**TITLE: AIR CONDITIONING - REMOVE INTERFERENCES BETWEEN ACSC  
AND LGCIU SIGNALS BY SHIELDING OF 47HH AND 57HH WIRE**

MODIFICATION No.: 153571K15409

This page transmits Revision No.01 of Service Bulletin No.A320-21-1208

Figure A-FBBAA - Sheet 01  
Installation of the Grounding Point 2208VN and location of the Grounding Point 2201VN.

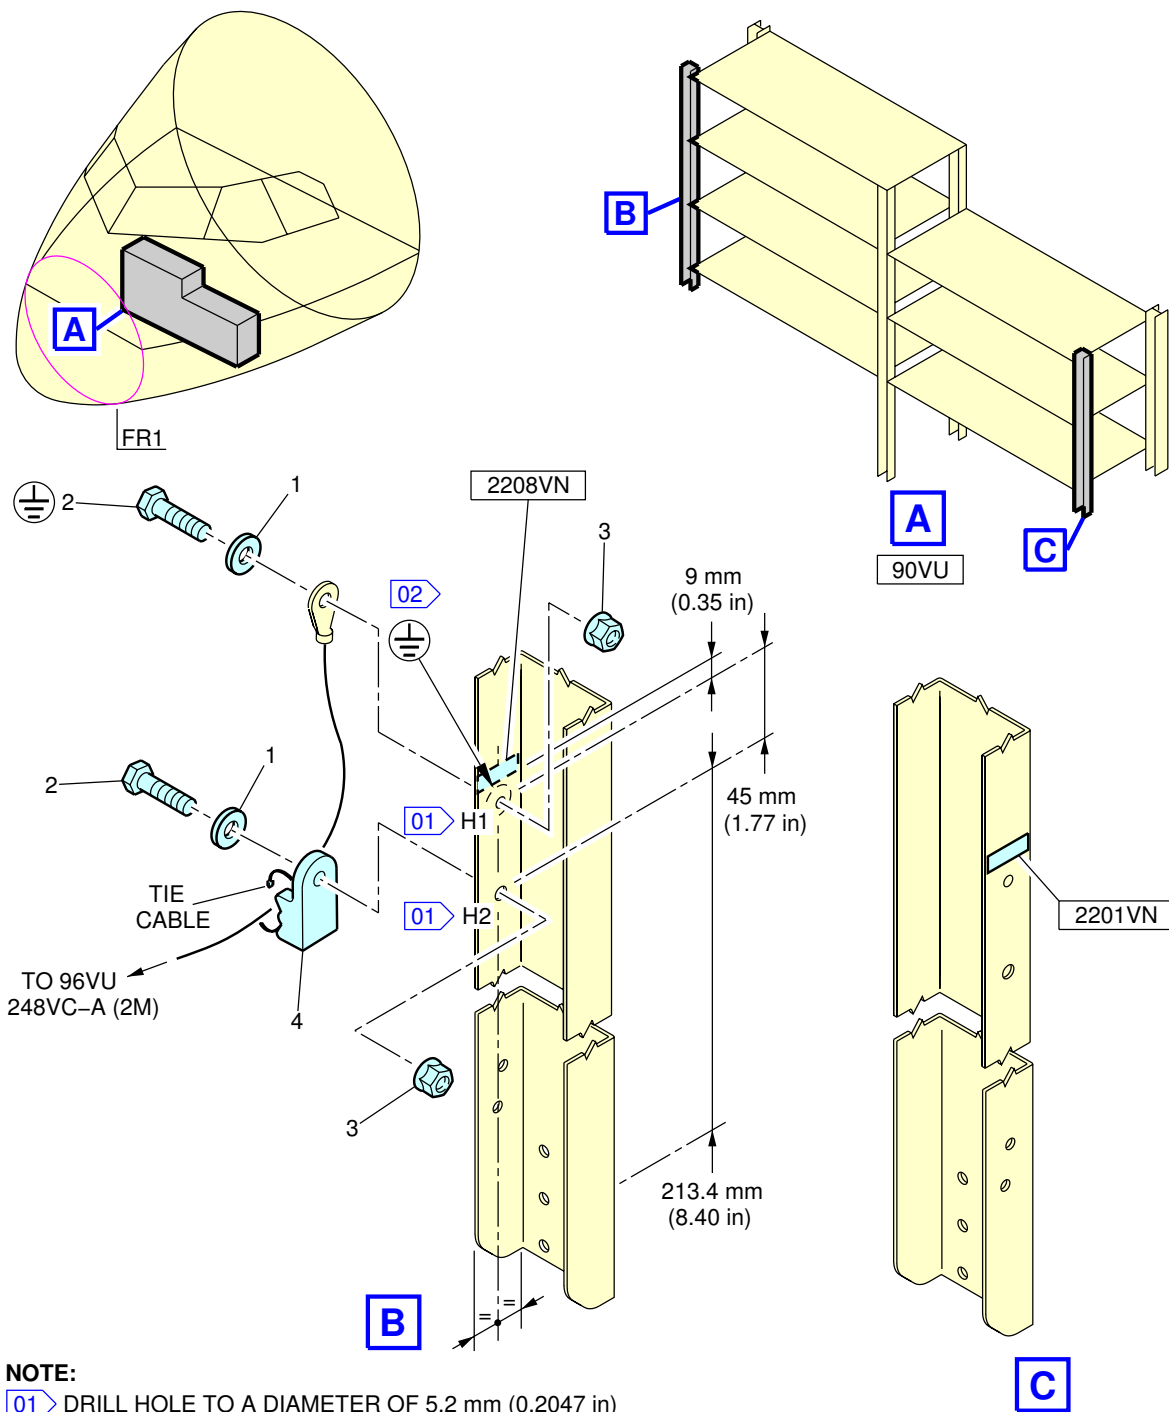
- Update the effectivity.
- Update the Kit references (administrative update) and to complete the Price and Availability.
- Delete 3009VN of the paragraph PROCEDURE and of the Kit A01, A02, A03.
- Update Illustrations to add the location of 2201VN and 3011VN.

(a) Install the grounding point 2208VN (Refer to [Fig. A-FBBAA Sheet 01](#)):

2 Remove the surface protection at the location of the shielding wire, in a diameter of 14 mm (0.55 in.).

Figure A-FBDAA - Sheet 01  
Modification of the Plate in the Cargo Compartment.

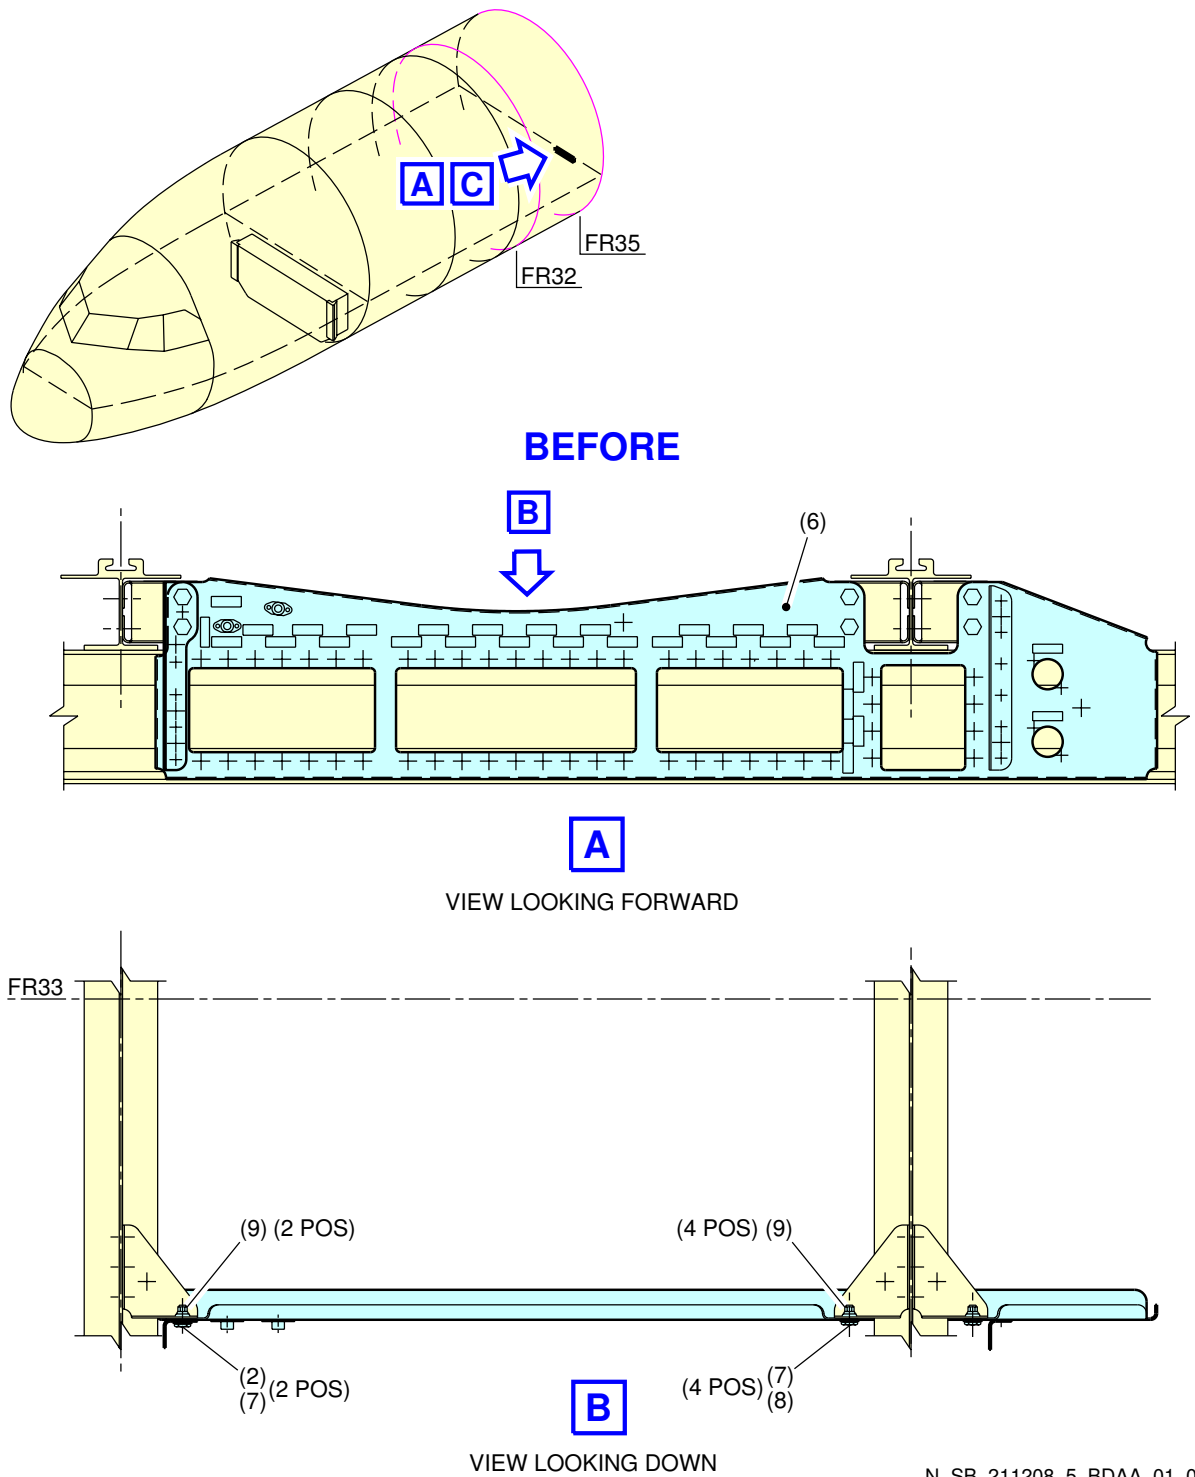
(a) Remove (Refer to [Fig. A-FBDAA Sheet 01](#)):

Figure A-FBDAA - Sheet 02  
Modification of the Plate in the Cargo Compartment.

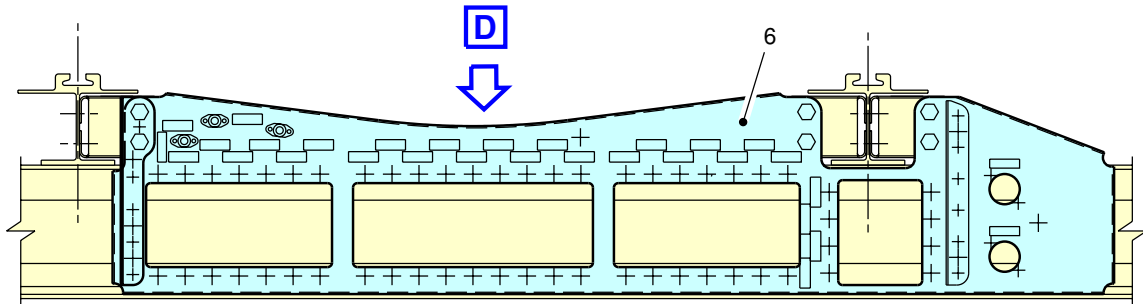
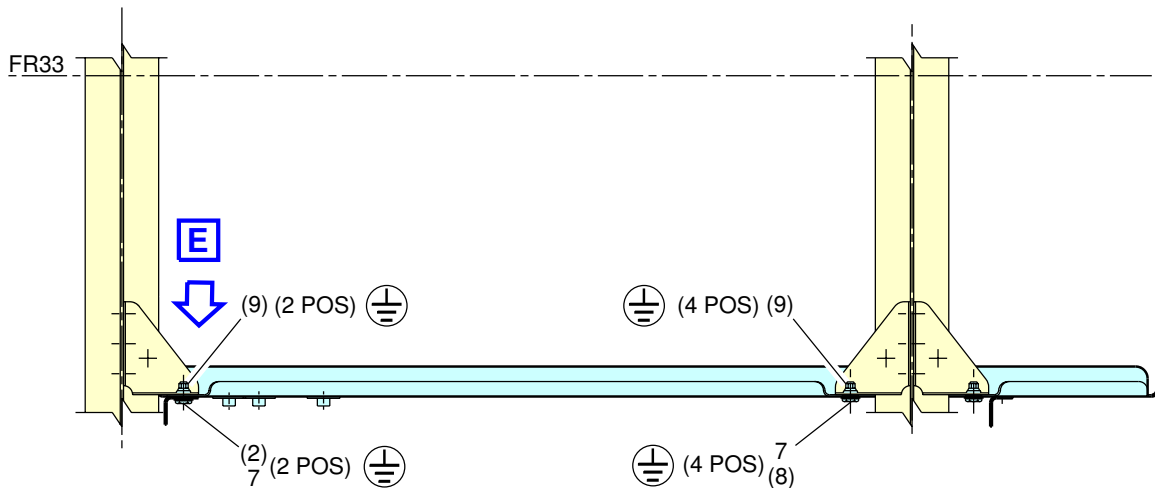
(b) Install (Refer to [Fig. A-FBDAA Sheet 02](#)):

Figure A-FBDAA - Sheet 03  
Modification of the Plate in the Cargo Compartment.

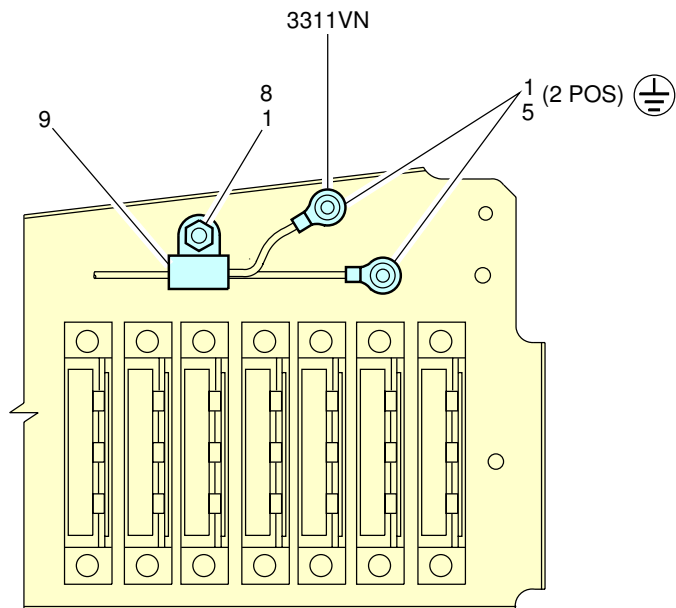
(c) Install the grounding point 3311VN with (Refer to [Fig. A-FBDAA Sheet 03](#)):

(d) Attach the shielding wires with (Refer to [Fig. A-FBDAA Sheet 03](#)):

Figure A-FBDAB - Sheet 01  
Modification of the Plate in the Cargo Compartment.

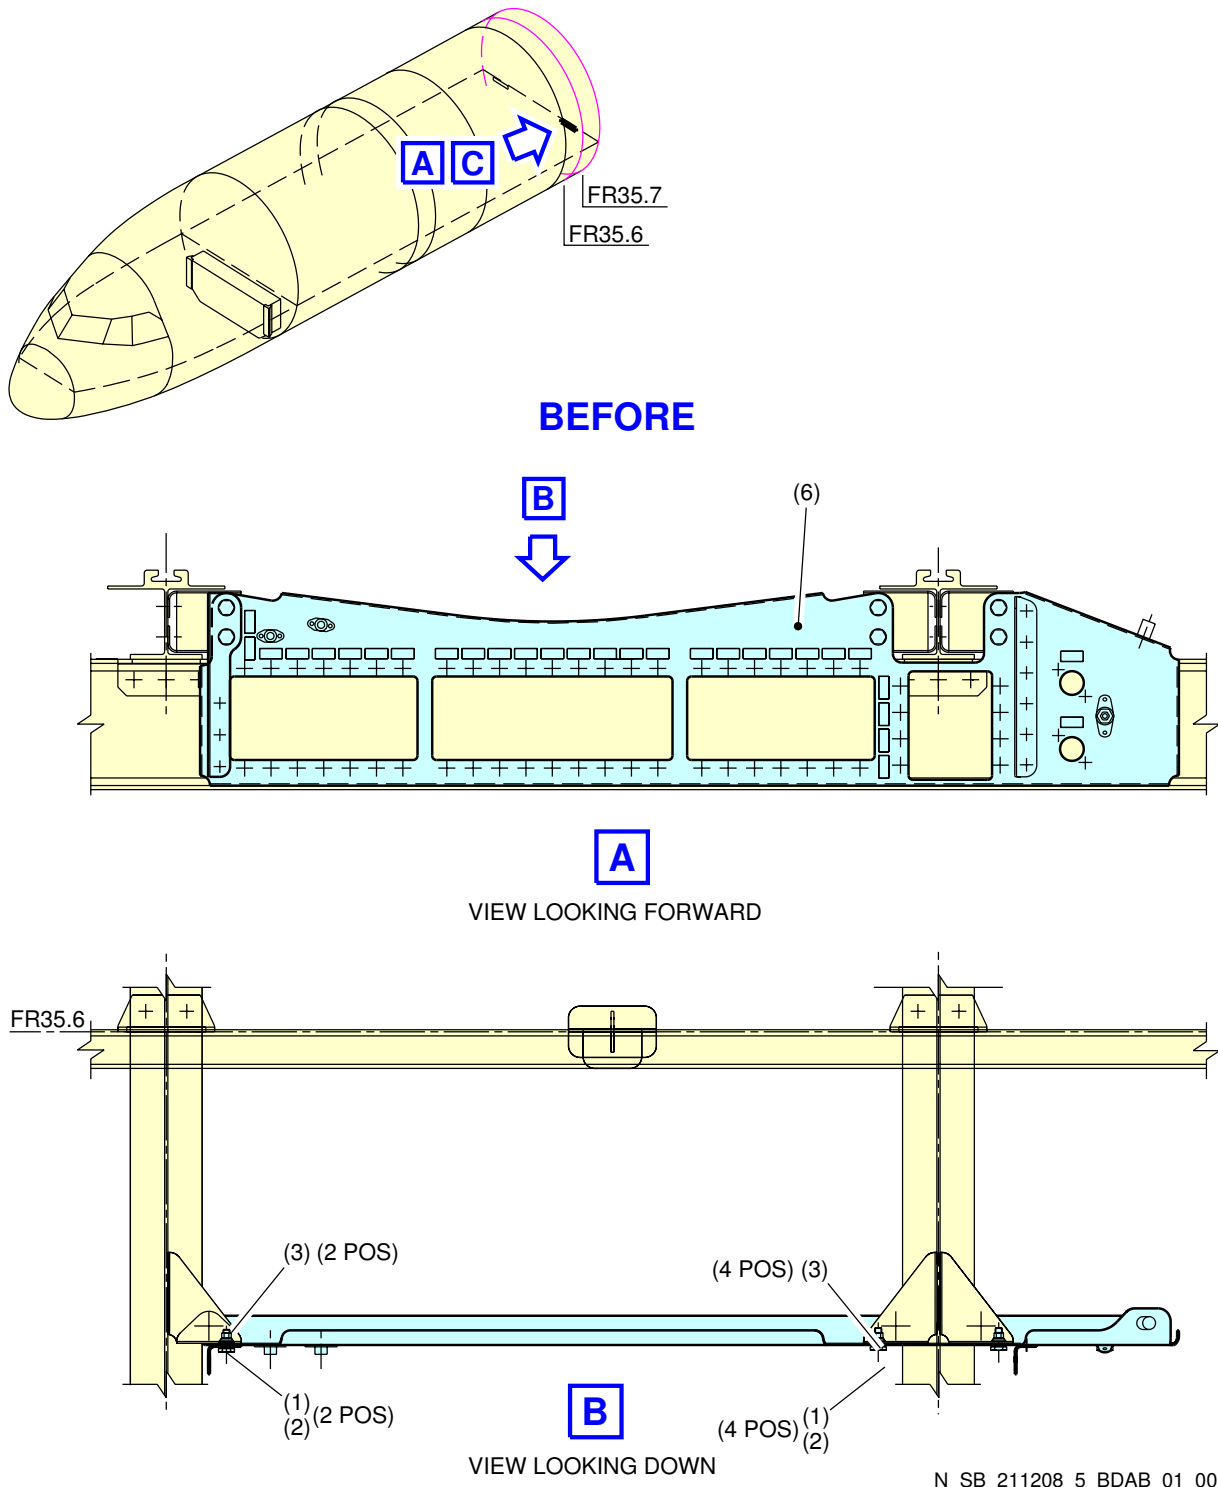
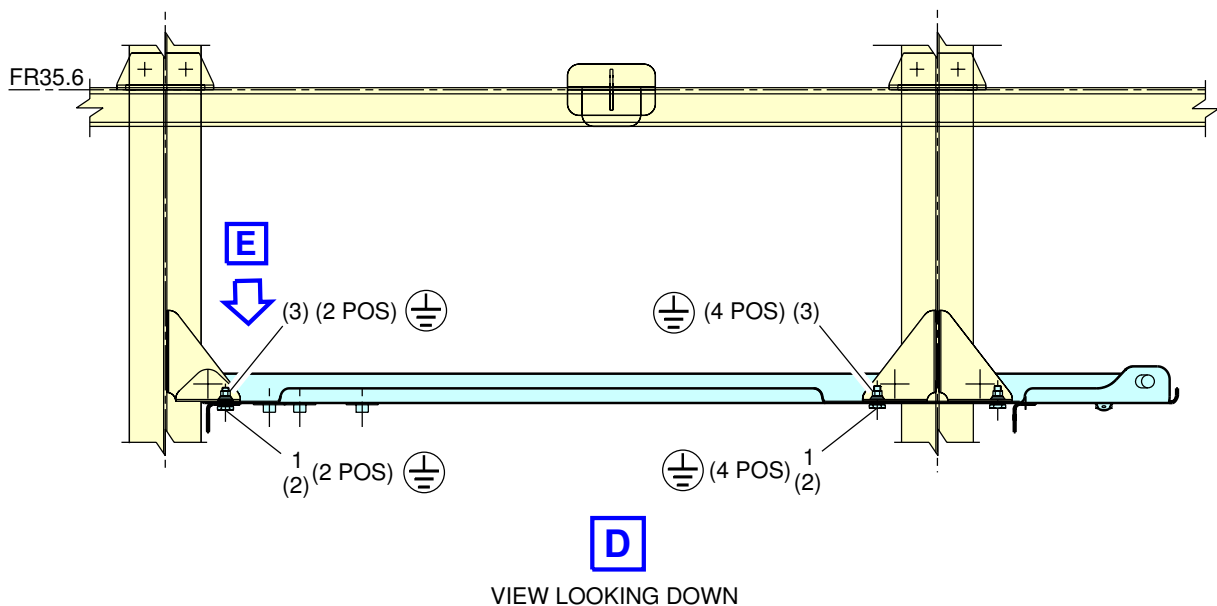
(a) Remove (Refer to [Fig. A-FBDAB Sheet 01](#)):

Figure A-FBDAB - Sheet 02  
Modification of the Plate in the Cargo Compartment.

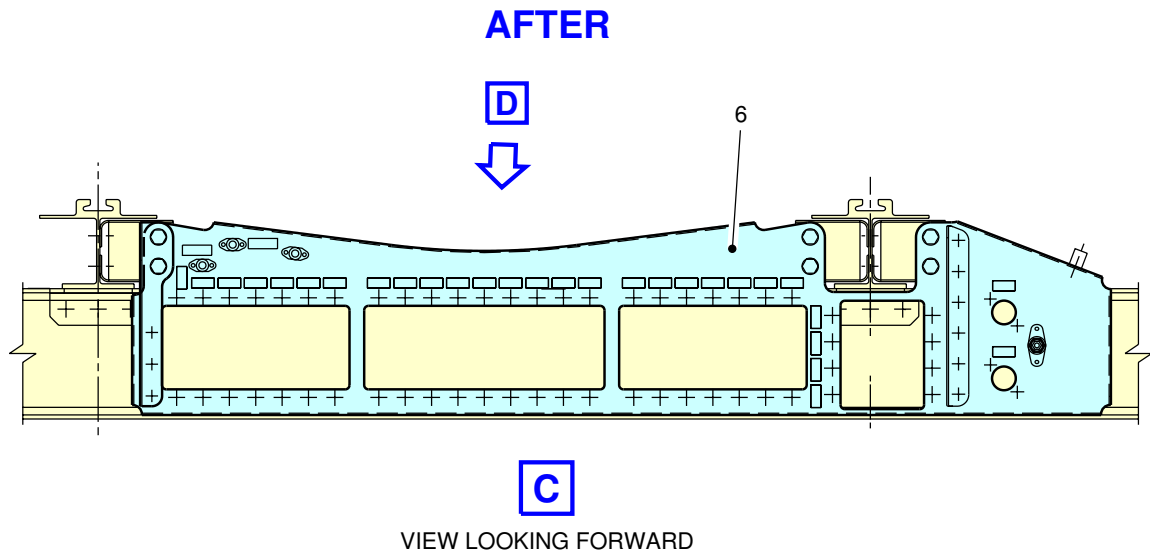
(b) Install (Refer to [Fig. A-FBDAB Sheet 02](#)):

Figure A-FBDAC - Sheet 01  
Modification of the Plate in the Cargo Compartment.

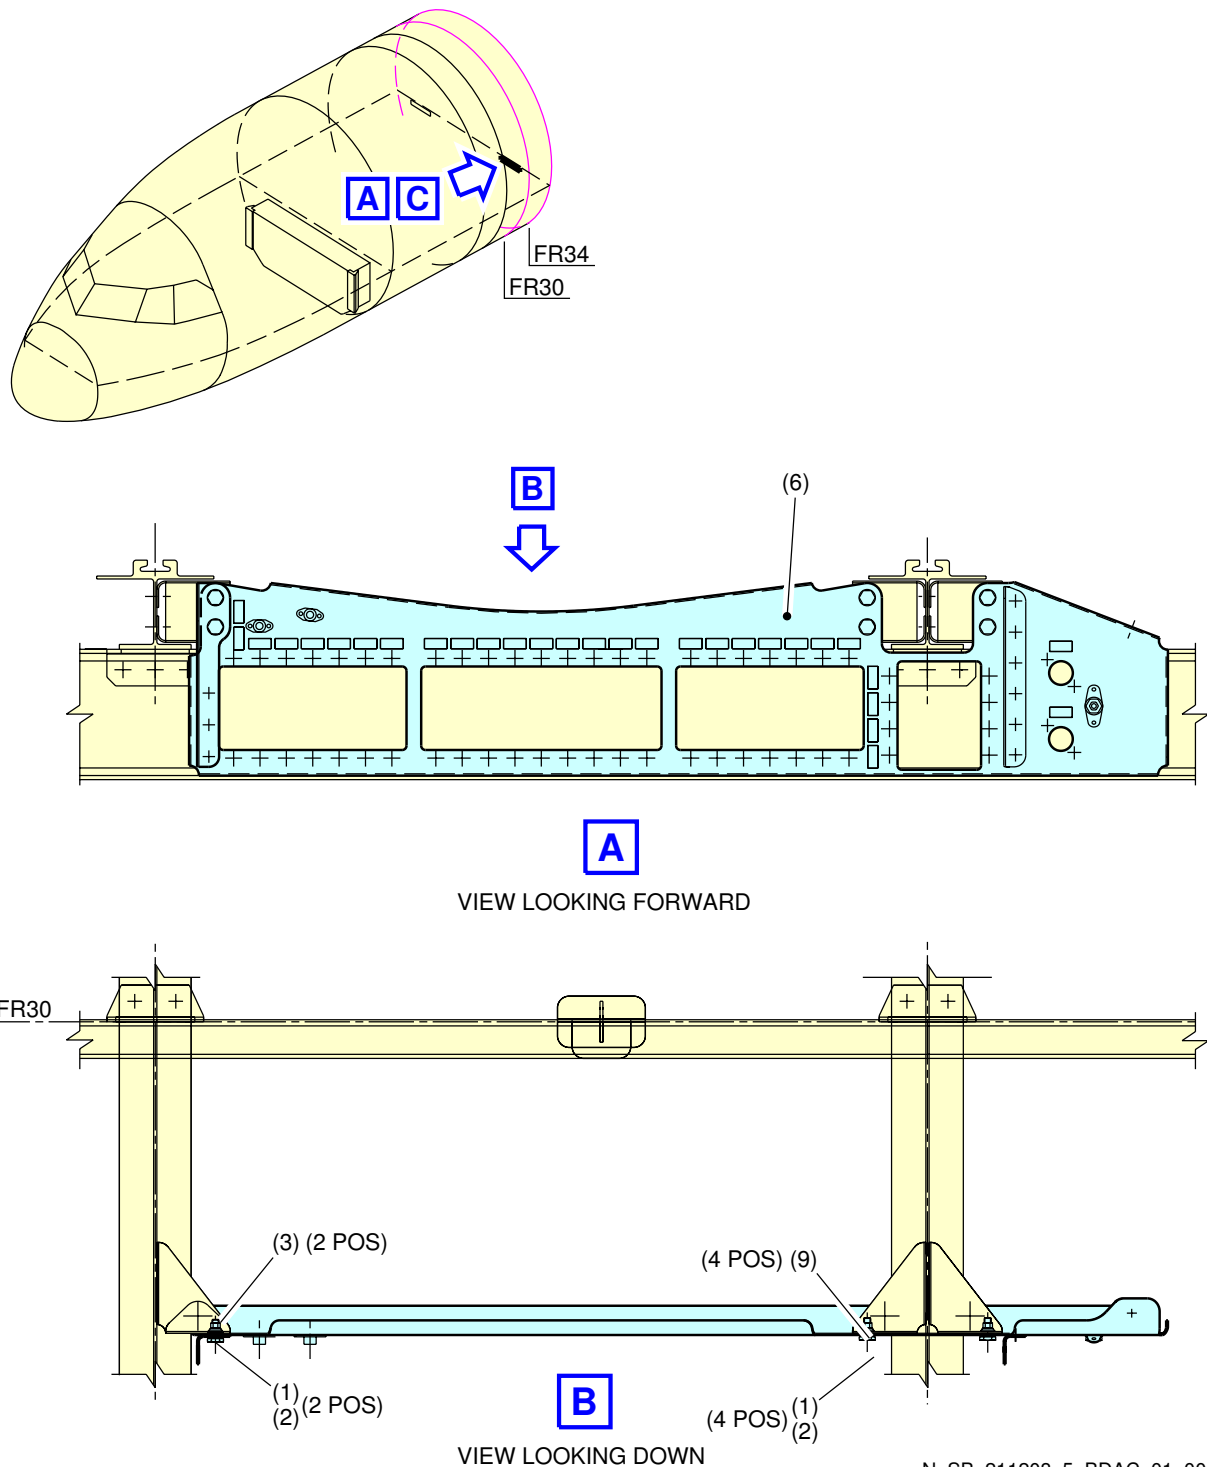
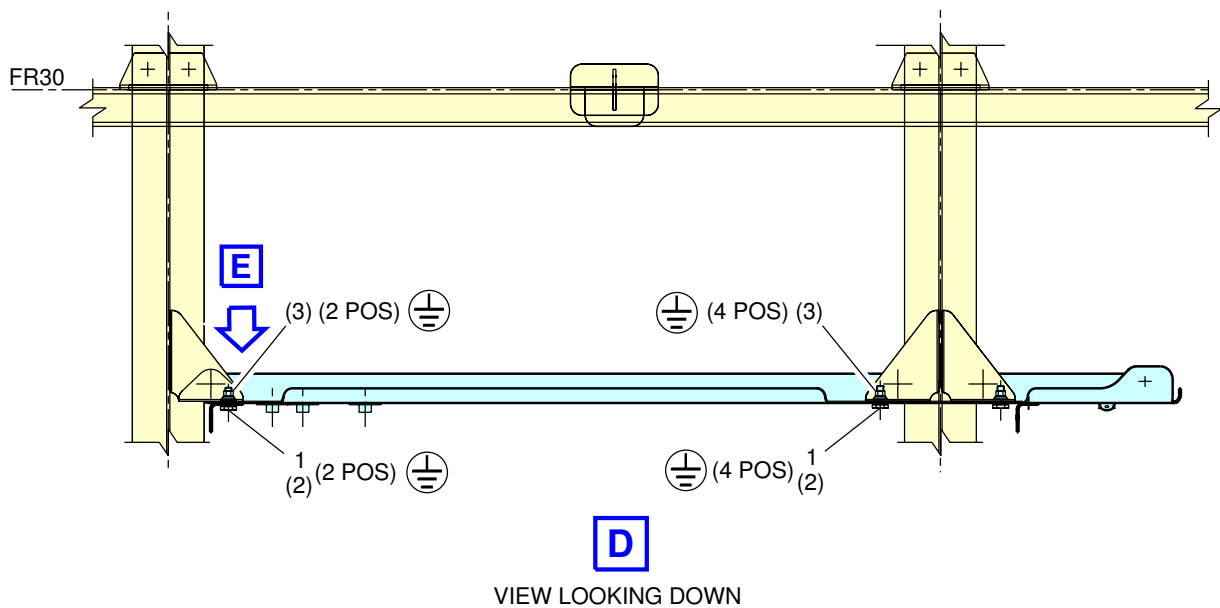
(a) Remove (Refer to [Fig. A-FBDAC Sheet 01](#)):

Figure A-FBDAC - Sheet 02  
Modification of the Plate in the Cargo Compartment.

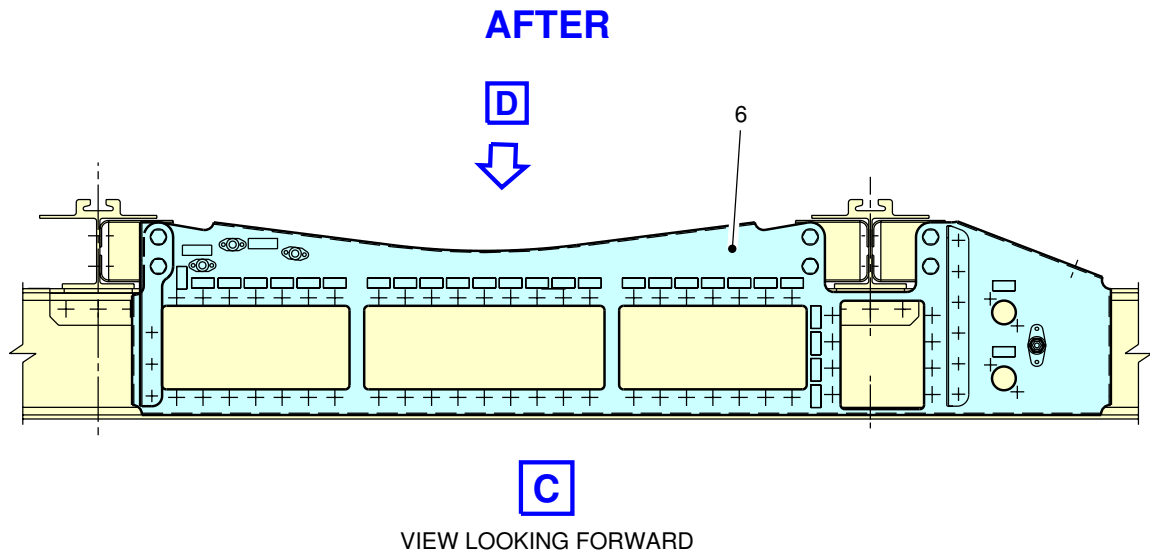
(b) Install (Refer to [Fig. A-FBDAC Sheet 02](#)):
